From:	Roshanak Rezaee s 9(2)(a)
Sent:	Tuesday, 21 March 2023 3:45 pm
То:	Isobel Lee
Cc:	Philip Brown; Michelle Kemp; Sam Sarah
Subject:	RE: Metlifecare Whenuapai - Outlet Structure Query

Subject: Metlifecare Whenuapai - Outlet Structure Query

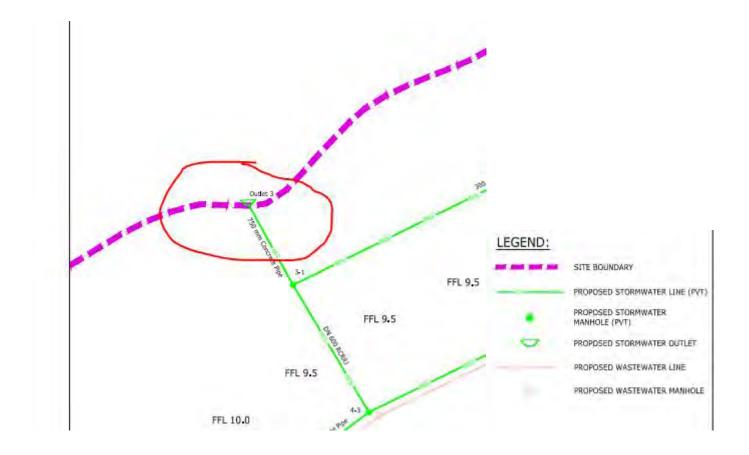
As discussed, we are wondering if the structure for the below proposed stormwater outlet will be located above the Mean High Water Spring? This is to help us determine consenting matters regarding the Coastal Marine Area that borders the site and an indication that the stormwater outlet structure will be located above the MHWS would make it a lot clearer from a consenting perspective. Please let me know if you need any further information.

We have been advised by our survey team that MHWMS is RL3.3, so I believe our SW outlet will sit above this level.

MHWMS is at RL 3.30 in terms of NZ Vertical Datum 2016
